PLANNED UNIT DEVELOPMENT

STAFF REPORT Date: October 1, 2015

DEVELOPMENT NAME Doug Klyce, Klyce Enterprises

LOCATION 205 Furr Street

SITE PLAN

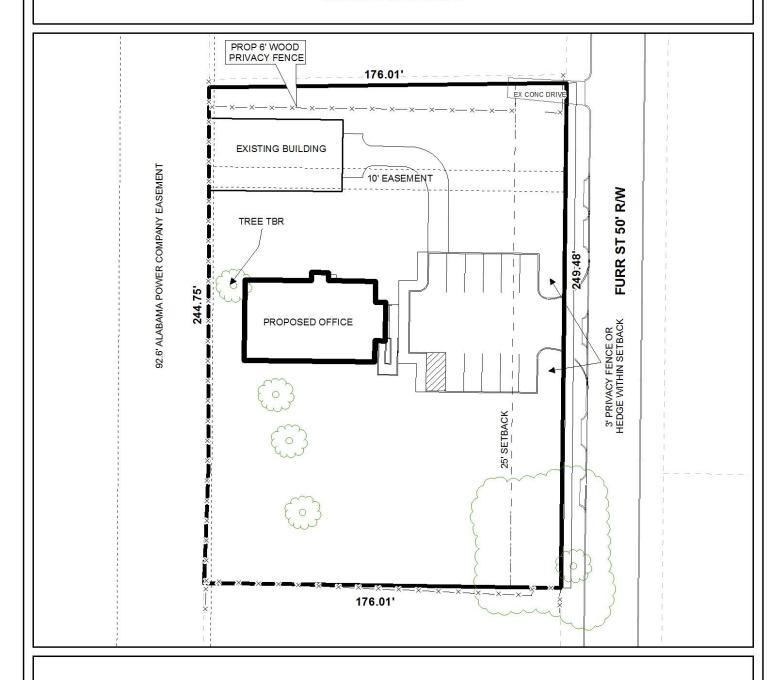
The revised site plan depicts the proposed building and parking facilities a distance of $50'\pm$ to the North in order to save two 24" Water Oak trees. In addition, a 10' wide asphalt path is depicted from the parking area to the front of the existing building in order to provide access and the previously required note regarding the elimination of cross-property access has been added to the site plan and should be retained on any revised site plan as well.

It should be pointed out that there does not appear to be a location of a dumpster or scale bar / scale notation on the site plan. The revised site plan should depict this information.

- 1) Revision of the site plan to depict the location of a dumpster in compliance with Section 64-4.D.9. of the Zoning Ordinance, to include a connection to sanitary sewer, or the provision of a note stating that waste collection will be via curb-side pickup;

- 2) Revision of the site plan to depict the location of any proposed freestanding sign structure;
- 3) Retention of all residential buffering and landscaping notes;

- 4) Retention of notes on the site plan stating that until a building permit for the construction of a wall along the western side of the existing building to prevent cross-property access, no additional permits for new construction on this site will be issued;

- 5) Placement of a note on the revised site plan stating (Any new lighting on the site must comply with the requirements of Sections 64-4.A.2., 64-6.A.3.c., and 64-6.A.8. of the Zoning Ordinance. All new lighting should be oriented in such a way that the illumination does not shine directly onto adjacent residentially used properties.);

- 6) Placement of a note on the revised site plan stating (No permanent structure(s) can be placed or erected within any easement.);
- 7) Compliance with Engineering comments (1. Since the plan shows an existing driveway that is providing access to the property to the north (207 Furr St) an access (ingress/egress) easement must be provided. ADD THE FOLLOWING NOTES TO THE PUD SITE PLAN: 1. Any work performed in the existing ROW (right-of-way) such as driveways, sidewalks, utility connections, grading, drainage, irrigation, or landscaping will require a ROW permit from the City of Mobile Engineering Department (208-6070)
